THE CITY OF WALTHAM  
MASSACHUSETTS

**Boiler Replacement, Waltham Library**

**ADDENDUM NO. 3**

Sept 12, 2017

- NOTES:  
1. VARIABLE SPEED PUMP CONTROLLED BY 0-10VDC SIGNAL FROM BOILER.

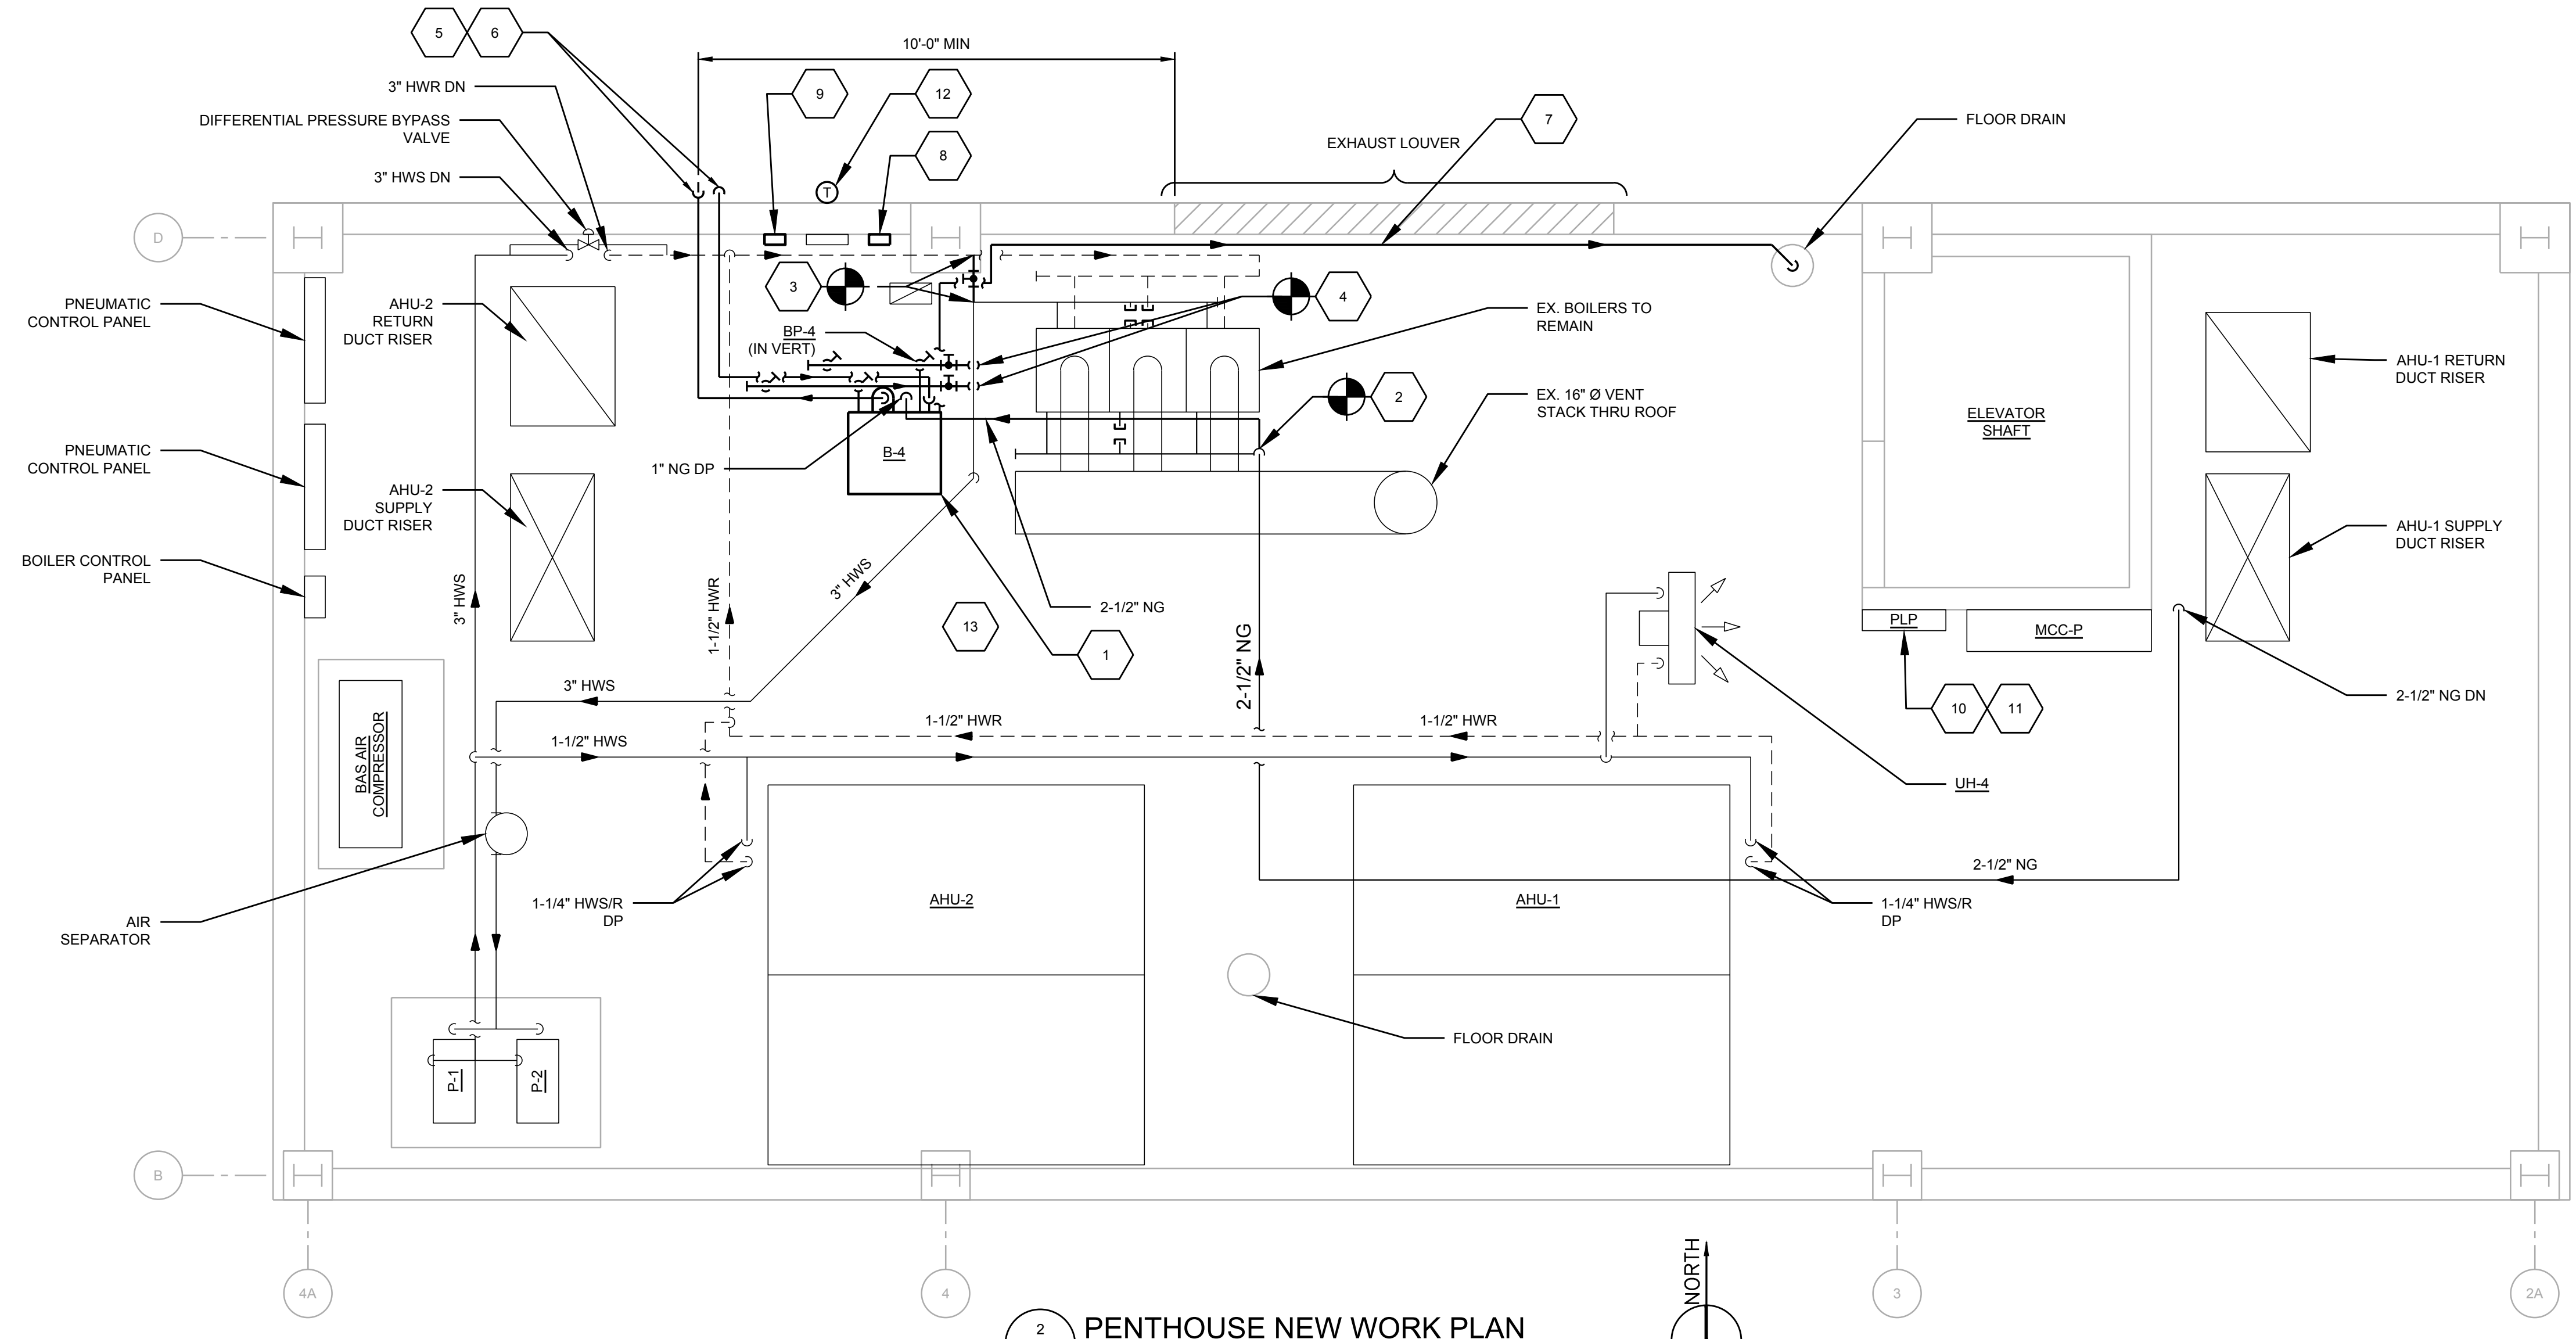
a) **DELETE** Drawings M-100 in the bid document and **REPLACE** WITH THE ONE ATTACHED HERE. The Drawings (M100 and M-200) have been modified to include the 'Sequence of Construction Notes' section, which addresses downtime of the heating system as discussed during the pre-bid meeting. Downtime will only be permitted Friday, Saturday, and Sunday, and will be coordinated with the owner.

SEQUENCE OF CONSTRUCTION NOTES

- HEATING SYSTEM DOWNTIME SHALL BE COORDINATED WITH THE OWNER, AND SHALL ONLY BE ALLOWED ON FRIDAY, SATURDAY AND SUNDAYS UNLESS TEMPORARY BOILERS ARE PROVIDED.
